Project Name: Marathon Gas Station/Convenience Store
Project Location: 1706 W. Northwest Highway
Planning Department Contact: Sam Hubbard, Planning and Community Development

Re: Marathon Gas Station- PC#16-016 Round 2

Address: 1706 W. Northwest Highway
Marathon Gas Station/Convenience Store
Special Use Permit for Automobile Service Station with
Convenience Mart
P.C. 16-016 Round 2

Project: Marathon Gas Station with Convenience Store
1706 W Northwest Highway

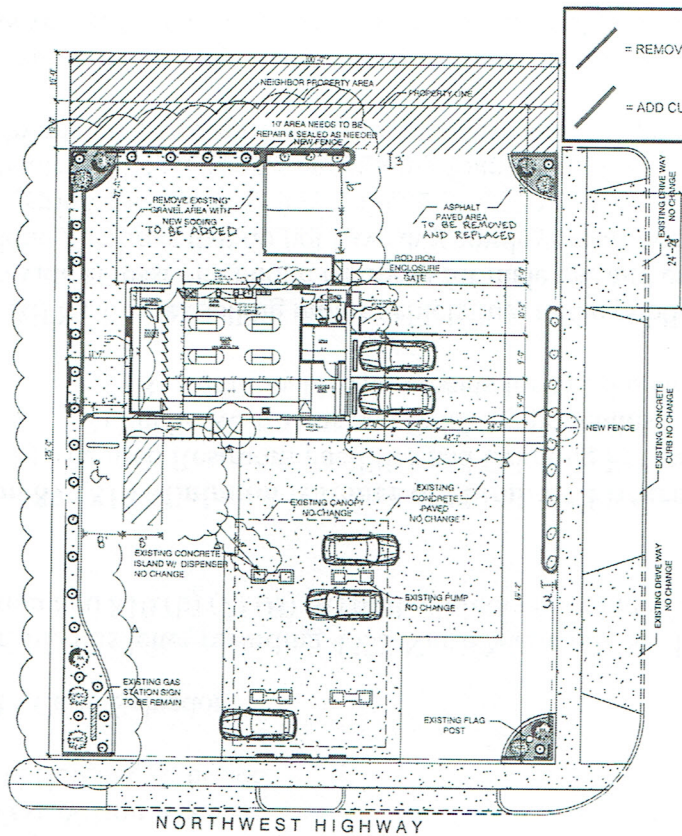
16. Add a note to the "Remove Existing Gravel Area With New Sodding" to clarify that the new sodding will be

added (see graphic). SEE ATTACH DWG A2, REVISION-2.

17. Curbs must be provided around edges of the landscape beds. The curbs around the landscape beds that abut the newly sodded area should be removed (see attached graphic). SEE ATTACH DWG A2, REVISION-2.
